**SERVICE BULLETIN No.11 / 2018****Information on the correct installation of the Bowden/activation cable**

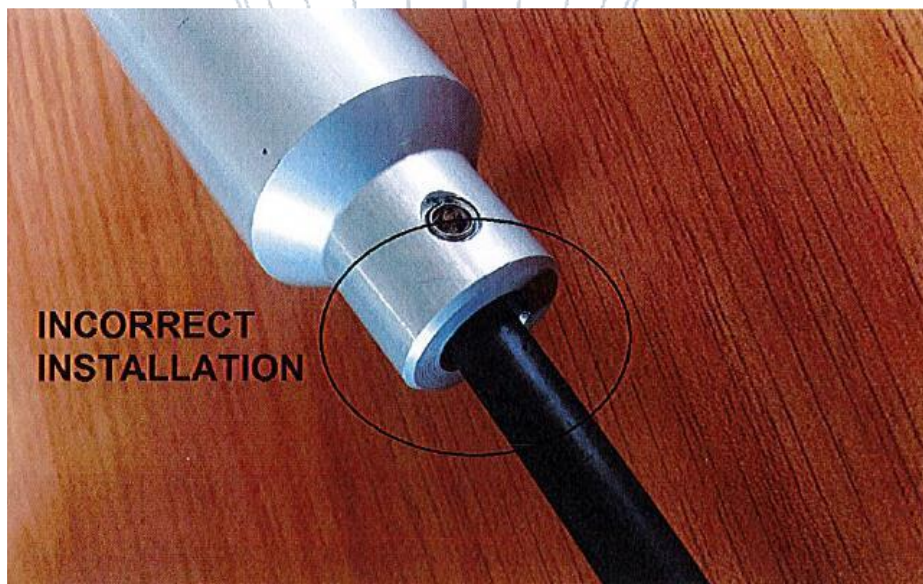
Persons concerned, who have performed the assembly of the activation kit of the Magnum rescue system with the rocket engine, shall make a visual inspection of the joint concerned on all Magnum rescue systems assembled by them.  
The inspection shall be done by pulling out the dispersive tube from the trigger body (see the following picture)
